Staff Report

To: Salt Lake City Planning Commission
From: Krissy Gilmore, Principal Planner, krissy.gilmore@slcgov.com or 801-535-7780
Date: August 14, 2019
Re: Navajo Street- Planned Development and Conditional Use (PLNSUB2019-00461 & PLNPCM2019-00557)

Planned Development & Conditional Use

PROPERTY ADDRESS: 1017 S Navajo Street/1335 W Mead Avenue
PARCEL ID: 15-11-301-001-0000
MASTER PLAN: Westside
ZONING DISTRICT: R-1/5,000 (Single Family Residential)

NEW SITE PLAN
A0.3

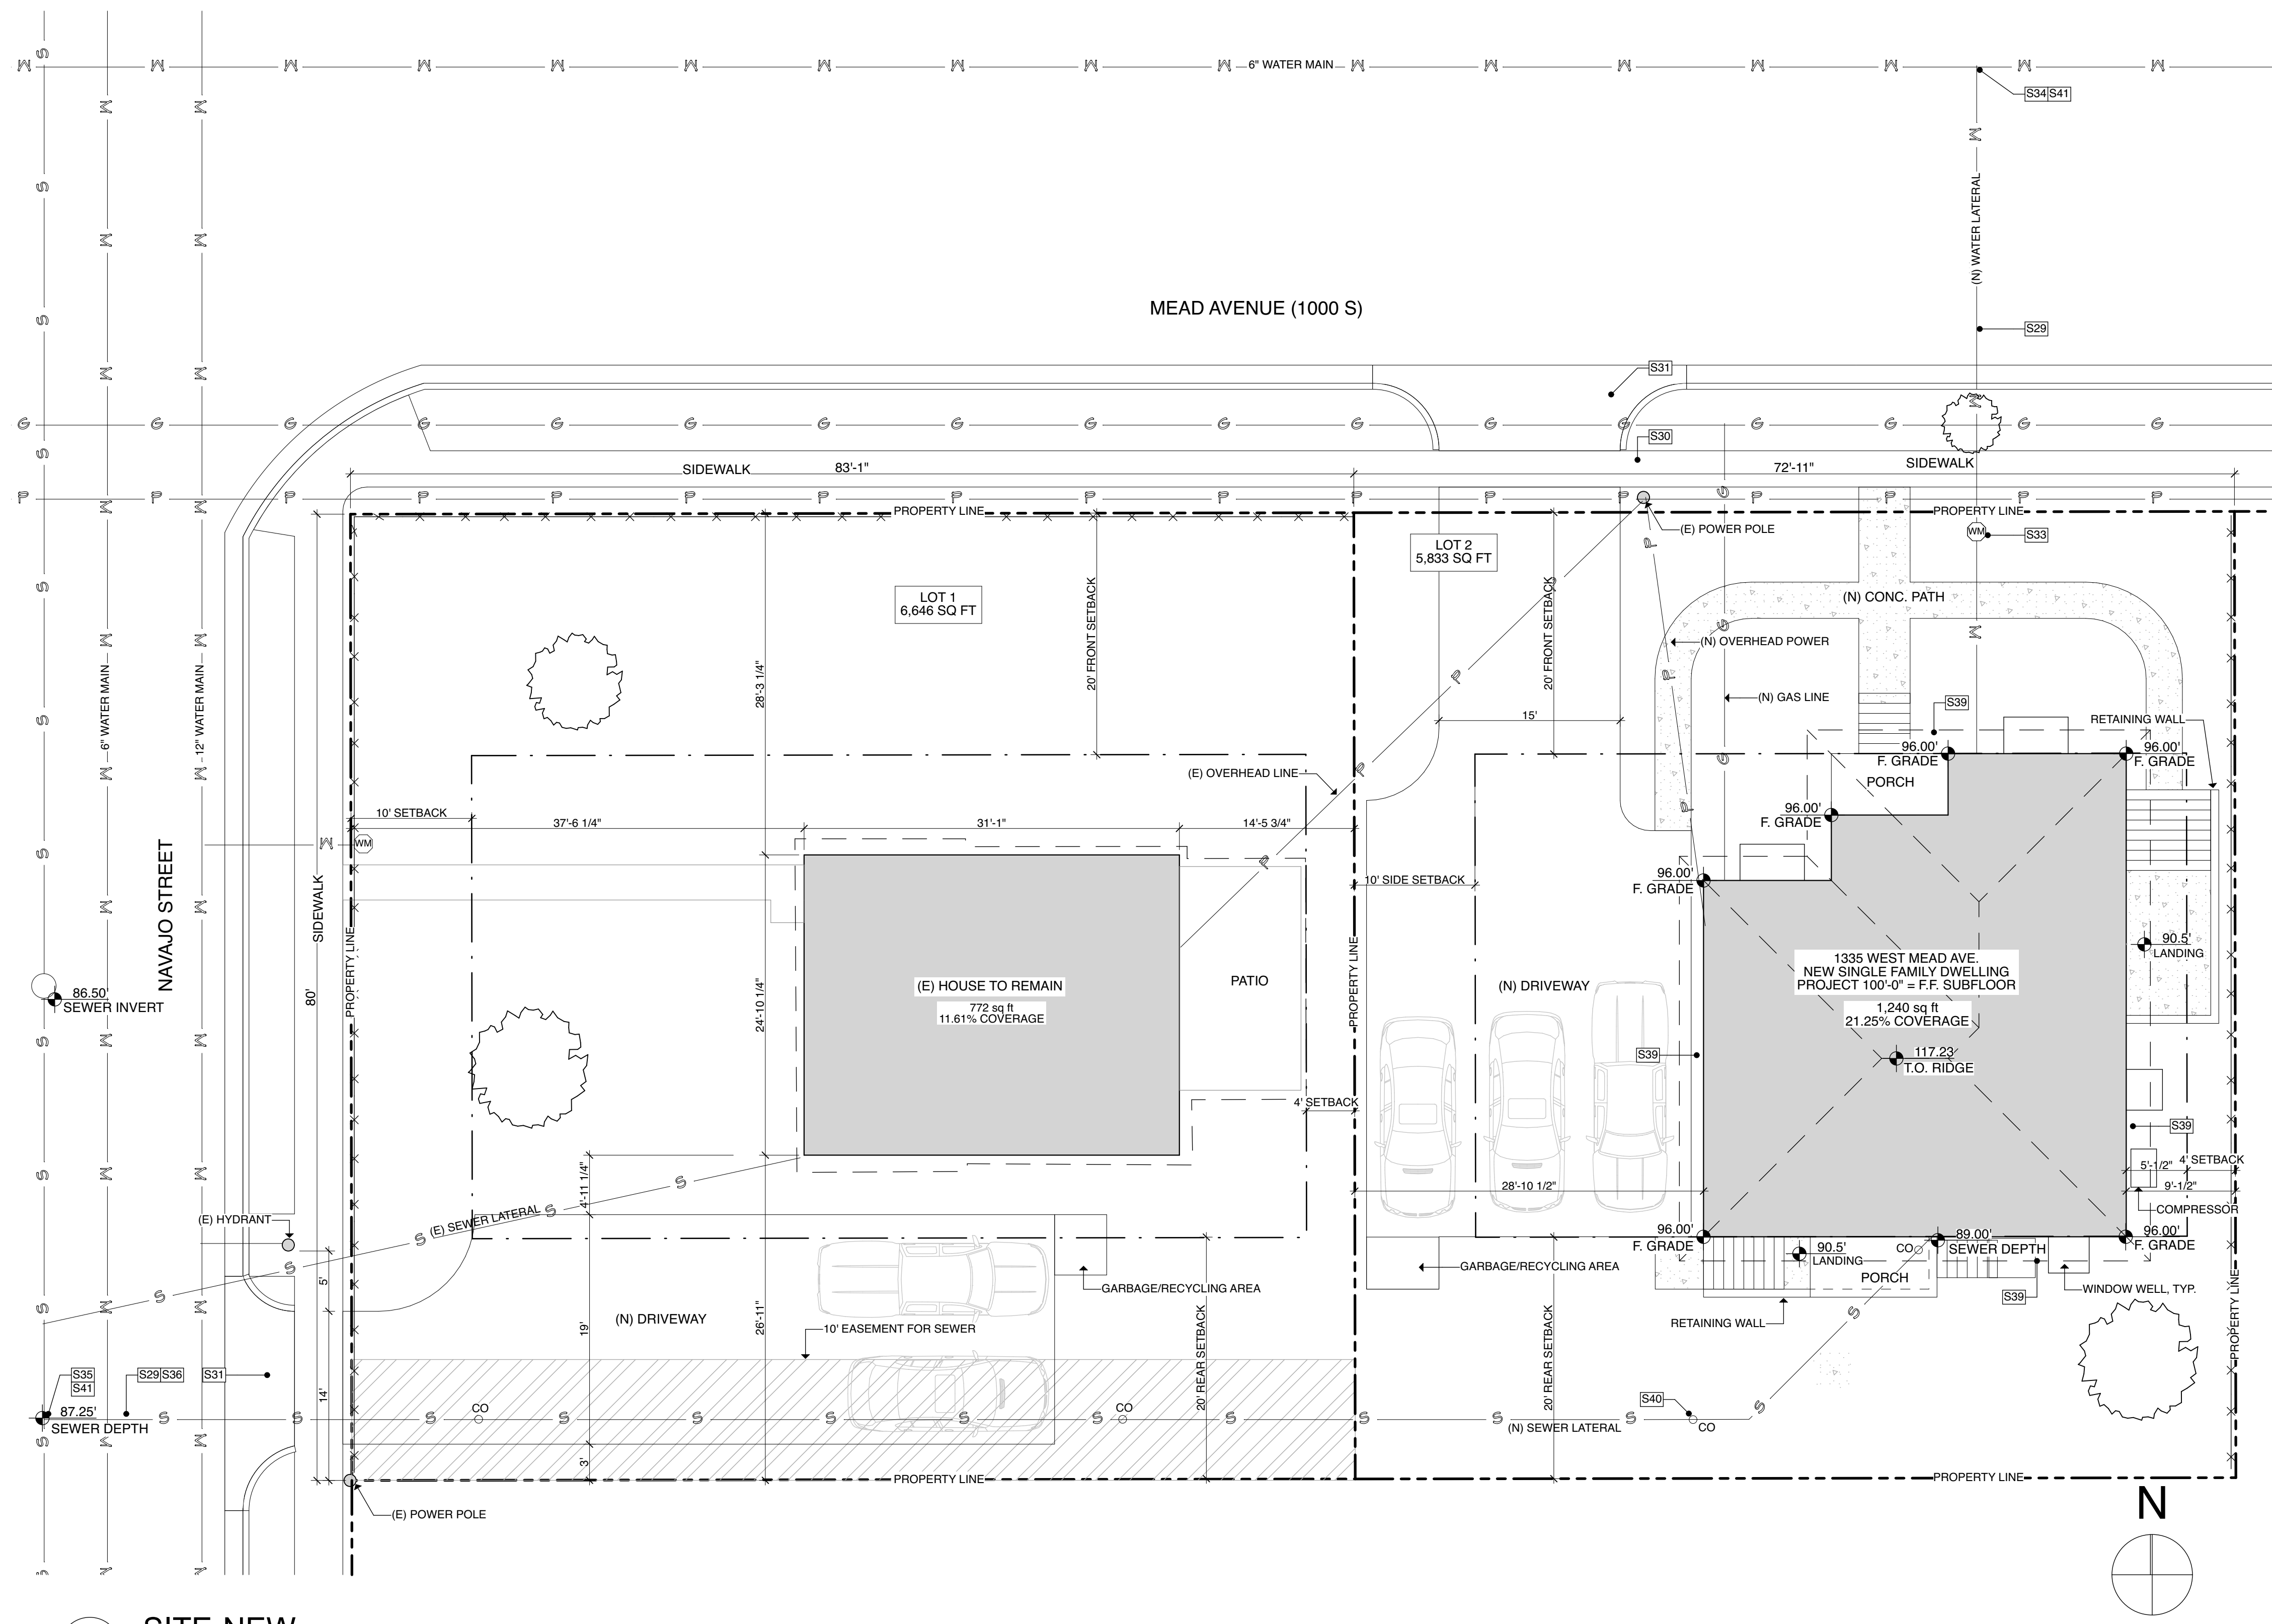
In regards to the Planned Development, Public Utilities is providing comment on the sewer lateral easement shown in the design drawings packet. Property is served by a 10" sewer main in Navajo Street. An easement will be required for the private sewer lateral that will cross the adjacent property to Navajo Street. Easement is currently shown on plan as 2 feet wide with the sewer lateral not included in the easement. The easement must be a minimum of 10 feet to allow for maintenance and operation of the sewer lateral. Additionally, the sewer lateral must run through the center of the easement, with adequate spacing on each side for maintenance of the sewer lateral.

1. Need parcel numbers shown on each lot.
2. Applying for a grade change larger than 4' –special exception needed to take care of the grade change & the stairs need to be within the buildable area of the lot (PUD can take care of setback requirements).

3. Each lot will require a minimum of 50' width; lot lines are not dimensioned.
 - a. **Planning Response:** *Lot lines are dimensioned: Lot 1= 83'1, Lot 2: 72'11*

4. Each lot will require 33%+ landscaping in required yards; both, the front & corner lot will have to have 33%+ in the required yards.
 - a. **Planning Response:** *They appear to be over 33%, assuming the areas not shown as driveways or concrete paths are landscaped. I have suggested a landscape plan from the applicant, although it is not required as part of the planned development.*

- a. **Planning Response:** *A Special Exception is **not** required. A grade change exception is within the Planning Commission authority under a Planned Development.*
